# Norfolk Vanguard Offshore Wind Farm

# DCO Non- Material

# Change 2

Supporting Statement for increase in  
ducts and drills at Landfall

**Figure 1 Representation of what is consented within the Norfolk Vanguard DCO and what is being sought through this NMC application**

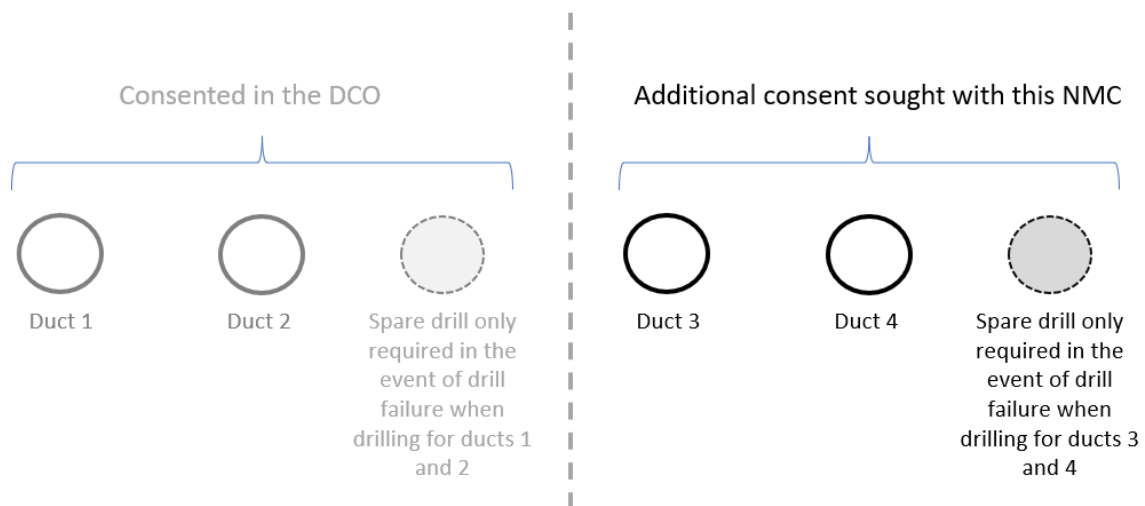
4. The Norfolk Vanguard DCO application assumed that, where the export cables were brought ashore through cable ducts, each cable bundle (one for NVE and one for NVW) would be housed within one single duct and therefore only two ducts would be required. However, as part of the detailed design process, it has been determined that the export cable bundle will need to be separated into two individual cables at an offshore location close to shore before being pulled through two separate ducts in order to make landfall (further detail is provided in section 1.2 and section 2). This will ensure the cables do not overheat. To facilitate this, a Non-Material Change (NMC) is being sought to amend the Order to increase the number of cable ducts at the landfall from two to four.

14. As described in section 1.1 the ES assessed impacts associated with a third drill (termed a reserve drill) for the purposes of providing a contingency in the unlikely event of a drill failure. The number of reserve drills was not directly secured within the DCO however as this formed the basis of the design envelope for the ES, the proposed change to the number of reserve drills required has also been considered in this document. In order to increase the number of ducts from two to four a second reserve drill will be required (i.e., one reserve drill for every two ducts). This additional reserve drill would only be required in the event of a drill failure. Therefore, this supporting statement assesses the impacts associated with adding this additional drill as well as the two extra ducts described above. Figure 1 illustrates the infrastructure which is already consented by the DCO and what is being sought additionally as part of this NMC application.

**Figure 2 Indicative locations of (and areas occupied by) Norfolk Vanguard infrastructure within the landfall zone**

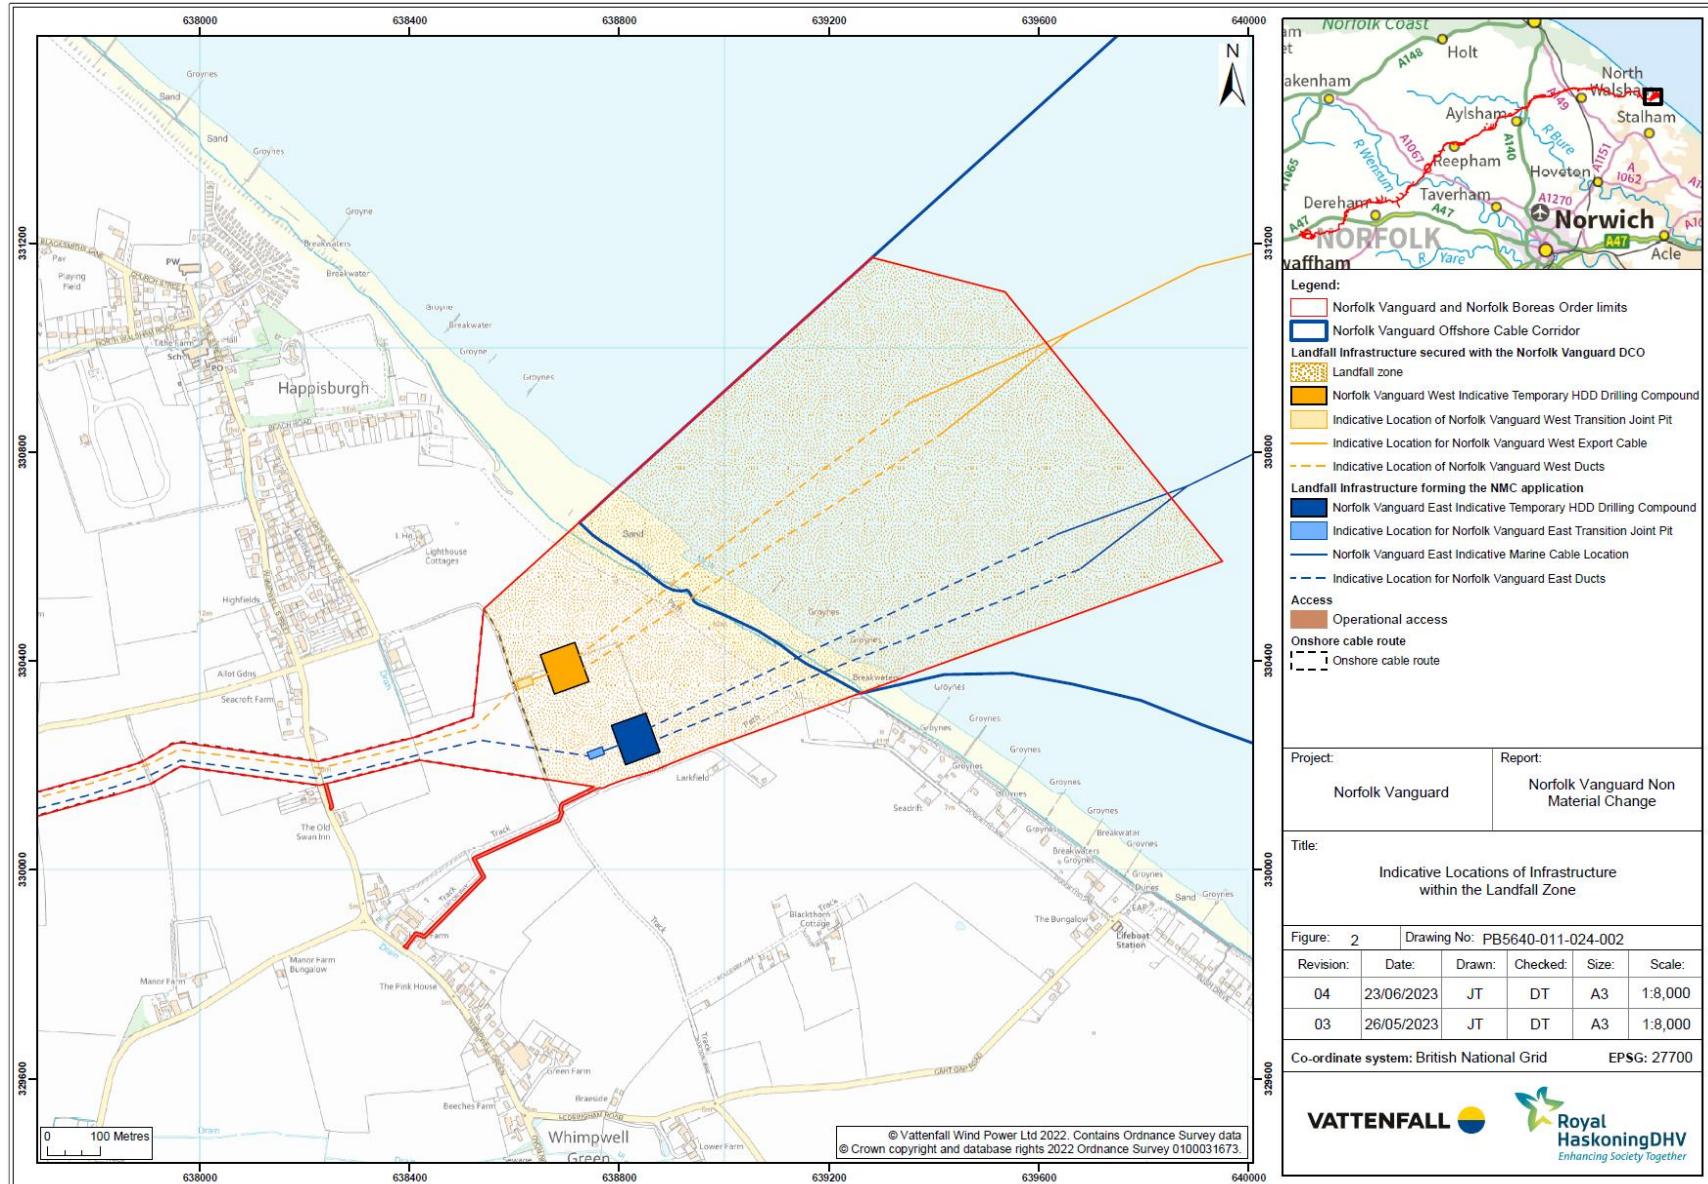
13. As part of the detailed design work, modelling and testing of the type of marine cables that will be required has shown that due to a combination of factors including the ground conditions around the cable entry point, and the physical properties of the cables themselves, cables, if bundled within the ducts are likely to reach temperatures at which the insulating material will start to degrade. In order to avoid this, it will be necessary to separate the positive and the negative cable (which together form the bundle) and locate them in separate ducts at landfall (see Figure

- 2). With two marine cable bundles (one from Norfolk Vanguard East and one from Norfolk Vanguard West) being separated on approach to shore, four separate ducts will be required at landfall to house the separated cables. Requirement 16 (14)<sup>1</sup> of the DCO restricts the number of landfall ducts for the Vanguard OWF to two and therefore this NMC application is seeking to change the DCO to allow for up to four ducts to be installed.

separate positive and negative cables to be pulled through separate ducts (as applied for within this NMC and described above) the cables would no longer be bundled on approach to the ducts allowing the cables to be buried in separate trenches. The separation point where the cables would no longer be bundled would be at a location between 500m and 750m to the east of where the cables enter the ducts as shown indicatively in Figure 2.
